**HISTORIC AND DESIGN REVIEW  
COMPLIANCE AND TECHNICAL ADVISORY BOARD**

**HDRC CASE NO:** 2024-108  
**ADDRESS:** 215 MUNCEY  
**LEGAL DESCRIPTION:** NCB 1660 BLK H LOT N 50 FT OF 15 & 16 ARB A15  
**ZONING:** R-6, H  
**CITY COUNCIL DIST.:** 2  
**DISTRICT:** Dignowity Hill Historic District  
**APPLICANT:** CUNNINGHAM TAYLYN & PAULINA  
**OWNER:** CUNNINGHAM TAYLYN & PAULINA  
**TYPE OF WORK:** Fenestration modifications  
**APPLICATION RECEIVED:** March 07, 2024  
**60-DAY REVIEW:** May 06, 2024; May 17, 2024; Hearing Confirmed by Applicant  
**CASE MANAGER:** Edward Hall

**Historic and Design Review Commission**  
***Design Review Committee Report***

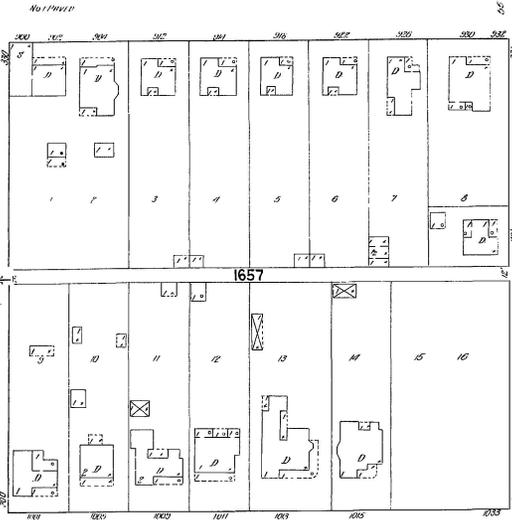
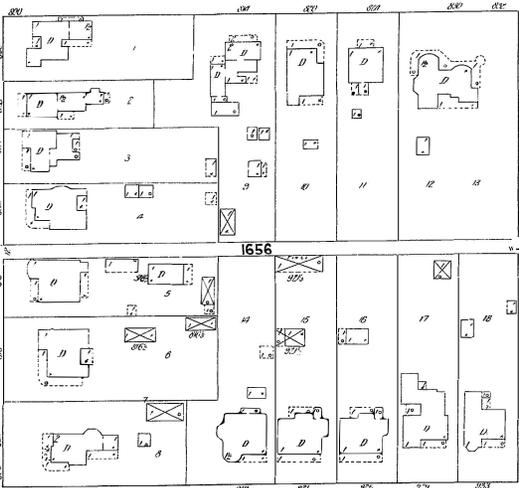
All: Comments/discussion on partially enclosed window.

JV: Recommends to build furr wall

MS: Typically the Commission asks elements to be returned to original. Given the previous modification, allowing the window to stay would be okay. JF: Add stucco to cement board with recessed opening. Or recessed brick. RF: In agreement. MS: First recommendation would be to have the full height window restored.

MS: Volume of the additional is stylistically in keeping with the main house - Victorian. Clerestory windows aren't appropriate in this context.

TC: Questions about visibility of rear addition and windows on rear addition.

MS: Rear addition is visible in places.
